Metropolitan Development Commission Regional Center Hearing Examiner (April 27, 2023) Meeting Agenda

STAFF REPORT

Case Number	2023-REG-026
Address (approx.)	402 Kentucky Avenue
Location	Center Township, Council District # 16
Petitioner	402 Kentucky Avenue, LLC, by Joseph D. Calderon
Zoning	I-4 (RC) and SU-18 (RC); CBD-2 (RC) pending
Request	Regional Center Approval to provide for demolition of an industrial building to redevelop the site for a proposed mixed-use development.

ELEVEN PARK
SITE PLAN

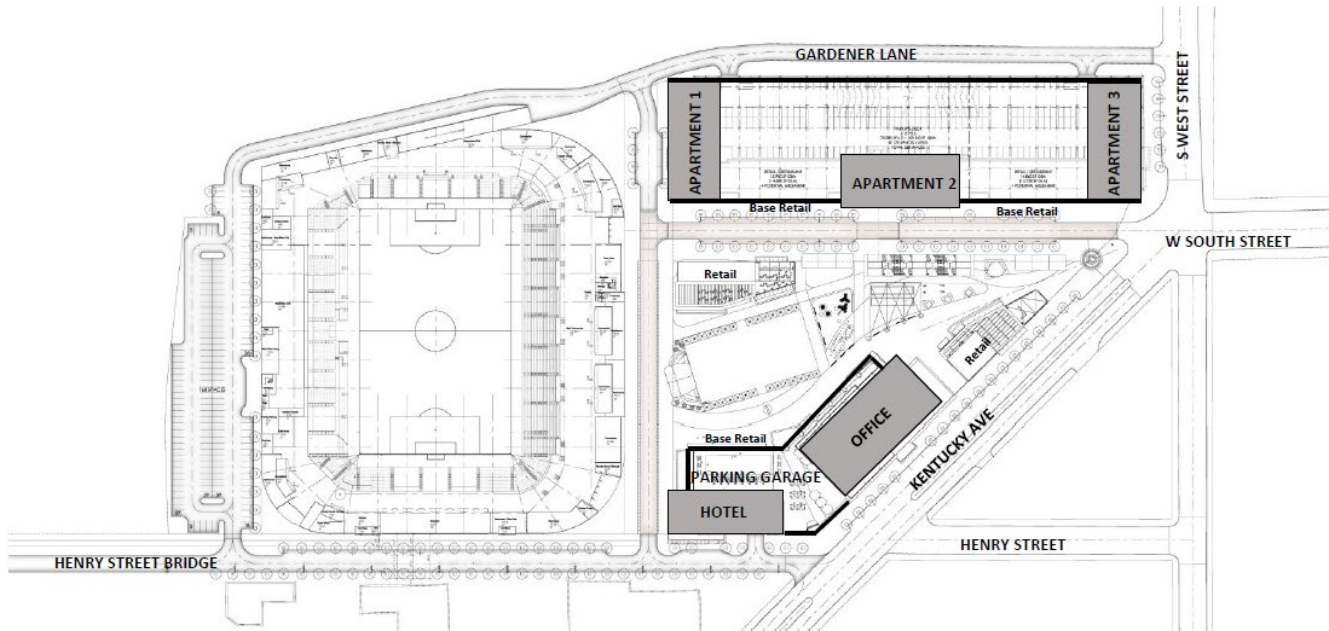
Review of the proposed plans against the Guidelines indicates one item remains outstanding:

Guideline US 2.2.1 indicates that sites listed on the *National Register of Historic Places* shall require consultation with the IHPC staff for review. Although this site is not listed on the National Register of Historic Places, the site is noted as 'Outstanding' in the *Indiana Historic Sites and Structures Inventory of Center Township* and has been determined to be eligible for the *National Register of Historic Places*. Staff consulted with IHPC staff during review of this request. The IHPC staff indicated that oversight by the State Historic Preservation and

Archaeology Office would be vital in review of the demolition of the building.

Staff **recommends approval** of the Regional Center Approval petition, subject to the following conditions:

1. The summary item must be met.
2. All signage, if any, within two years of MDC approval requires planning staff review and approval. After the two-year period, a new Regional Center Approval petition would be required for review and subsequent approval of any proposed signage. The design of all signage shall meet Guidelines CA 2.5.1, CA 2.5.2, CA 2.5.6 and CA 2.5.7.
3. If required by the Department of Business and Neighborhood Services, the address numerals shall be installed on the building façade (CA 2.5.8), prior to occupancy of the building.
